ARCHITECTURAL REVIEW BOARD WORK SESSION AGENDA

Agenda Item: Discussion - Pre-application ARB case, 13100 & 13150 Worldgate Drive

Subject: Pre-application ARB case, 13100 & 13150 Worldgate Drive

Agenda Item: Discussion - Architectural Review for ZMA#24-001, 250 Exchange Place

Figure 1: Diagram demonstrating common gable roof pitches, including 6:12 and 8:12. The 12:12 (high pitch) and 4:12 (low pitch) are included as points of comparison.

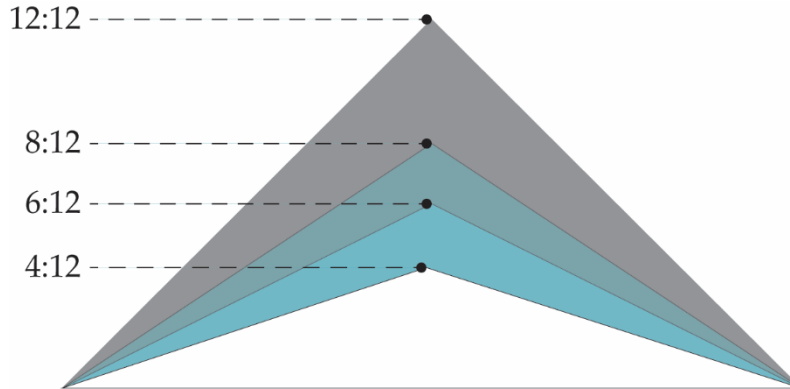
Building Configuration – Roof (p. 4): The standards pertaining to roofs have been updated to specify that either parapet, parapet concealed gable, or gable roofs must be used. However, the standards currently allow for gable roofs with a 6:12 pitch to be unconcealed. This is a relatively low pitch for a gable, and it conveys a prosaic suburban residential design that will be out of place when juxtaposed with the contemporary and innovative design of the multi-family building. Staff maintain that gable roofs with pitches below 8:12 should be required to be concealed by a parapet (*Figure 1*).

Additionally, the standards currently state that low-pitched gable roofs must be concealed by a parapet on the primary and secondary elevations. This means that the low pitch will be visible from the tertiary elevations, which corresponds with the rear or alley facing sides of this development. The unconcealed portion of the gable will therefore have a high degree of visibility from Private Roads A and B (*Figure 2*). The standards should be revised to require a parapet to screen low-pitched gable roofs on all sides.
